Project	UCLH4A - Phase 3 Cancer Centre
Subject	EWS-103 / EWS-410 Typical 5th floor facade type with solid spandrel panels
Architects	Hopkins Architects Ltd 27 Broadway Terrace, London, NW1 6LG T: 020 7724 1751 E: mail@hopkins.co.uk

Sort Code	Drawing Number	Rev.
A / UCLH4A	5004	L
Date	16.01.09	Scale 1:20 at A1

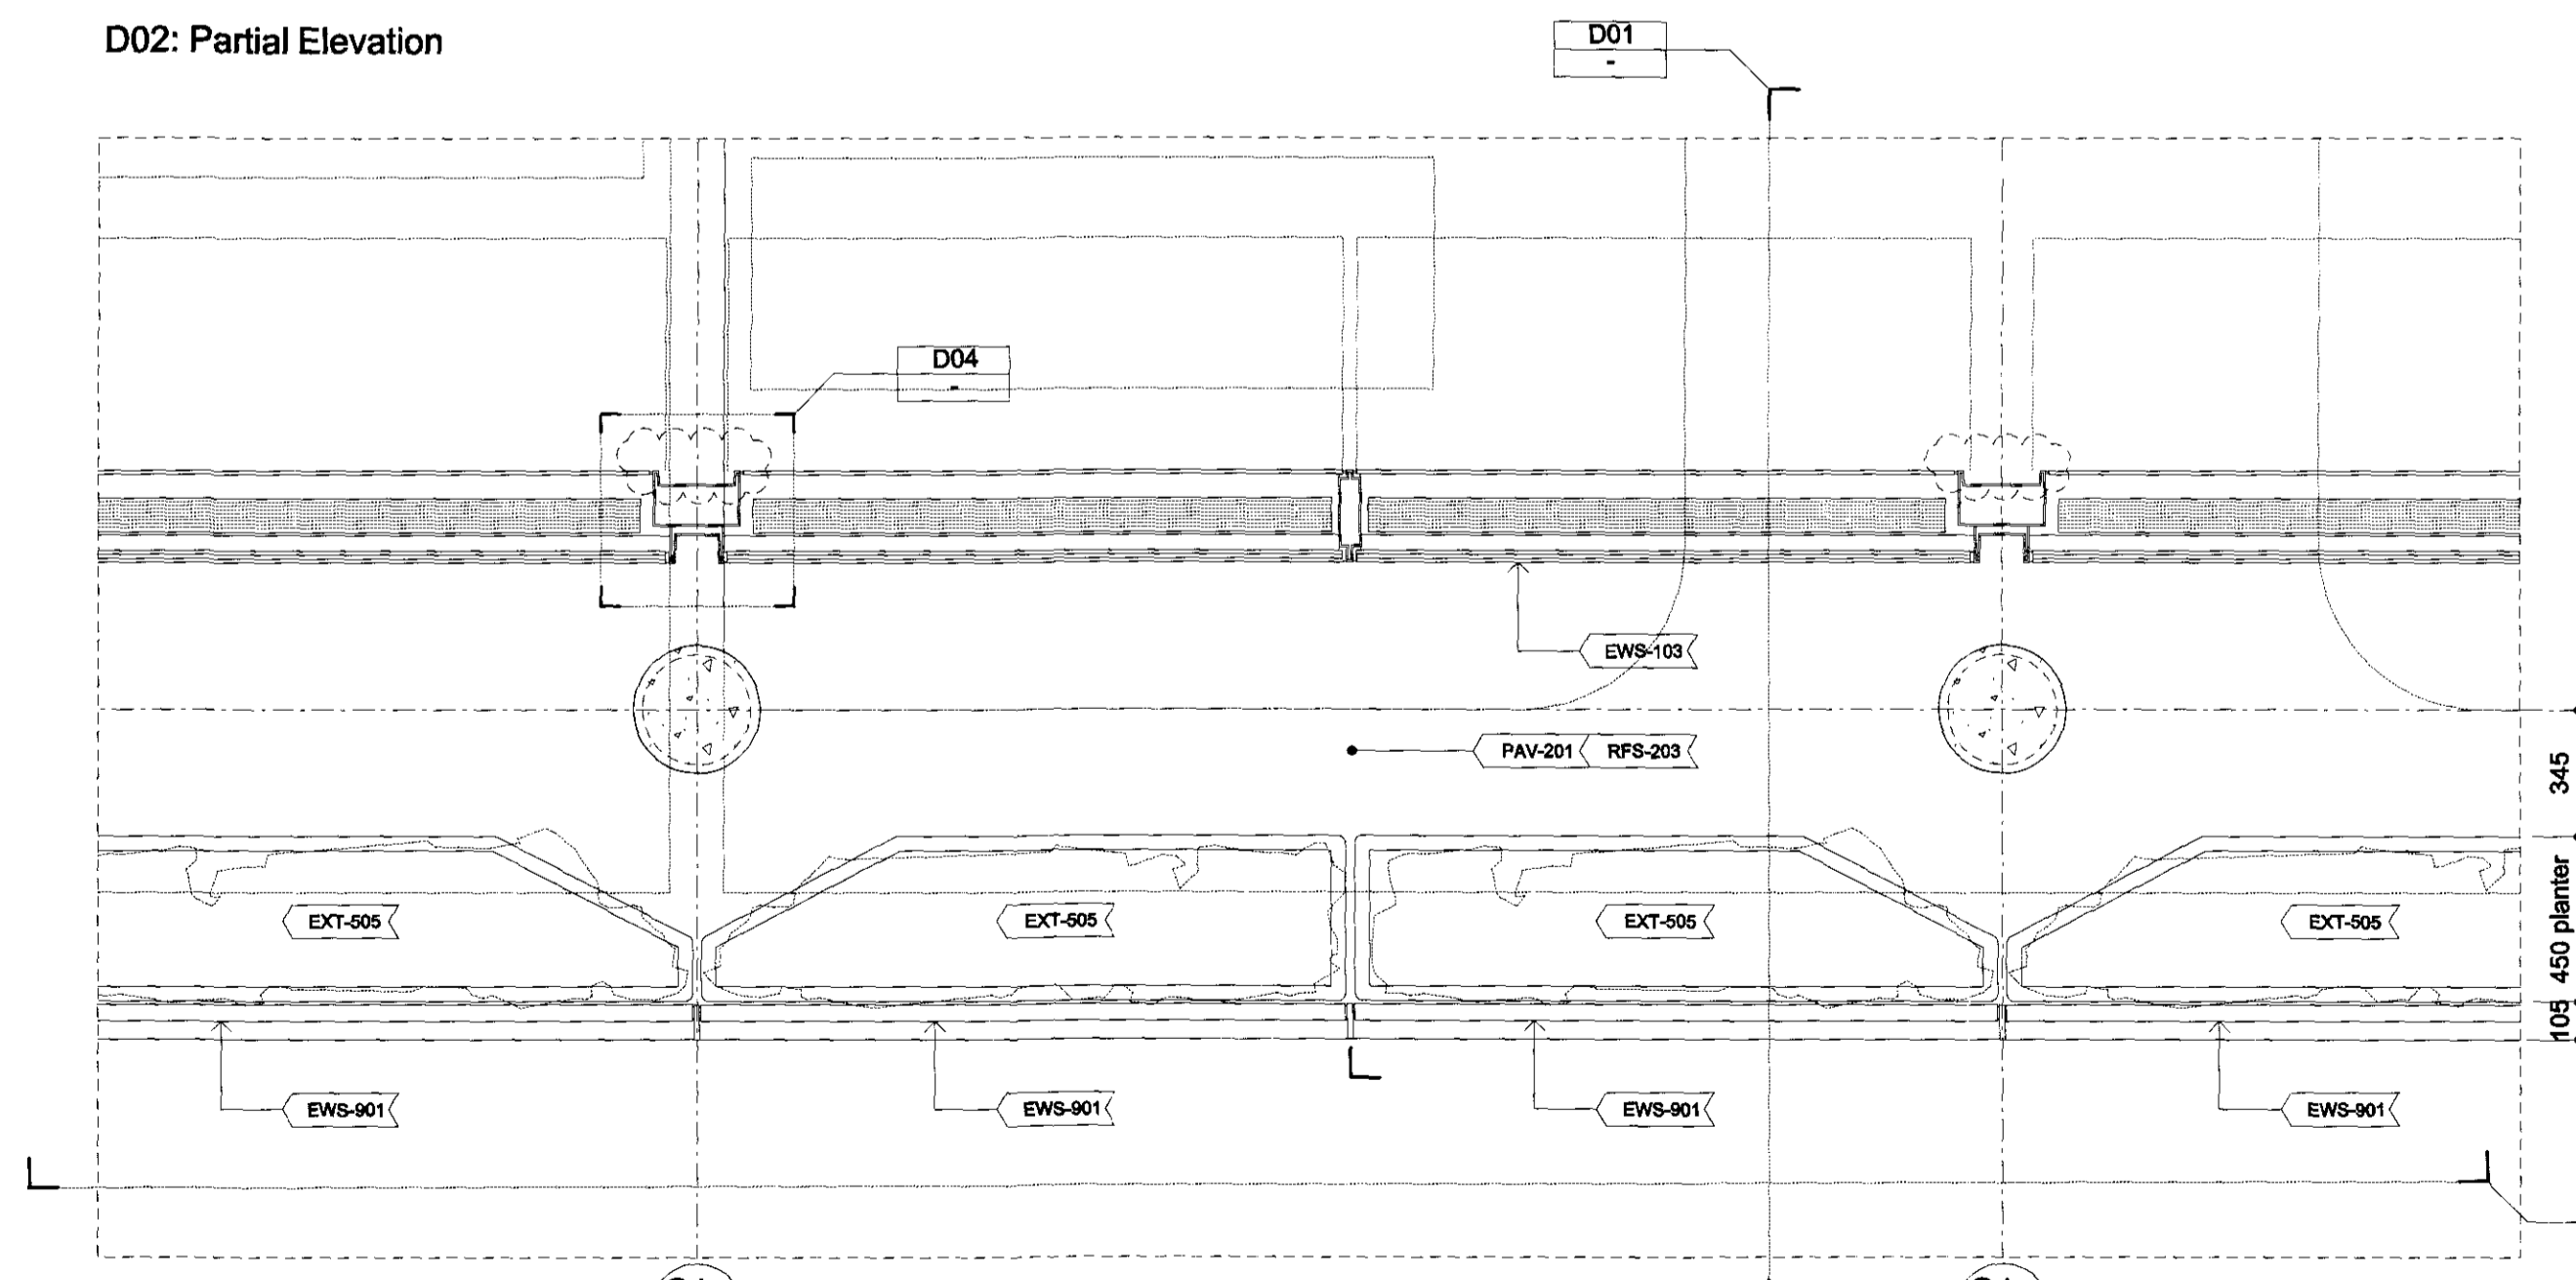
Detail 03 removed: bronze column cladding omitted
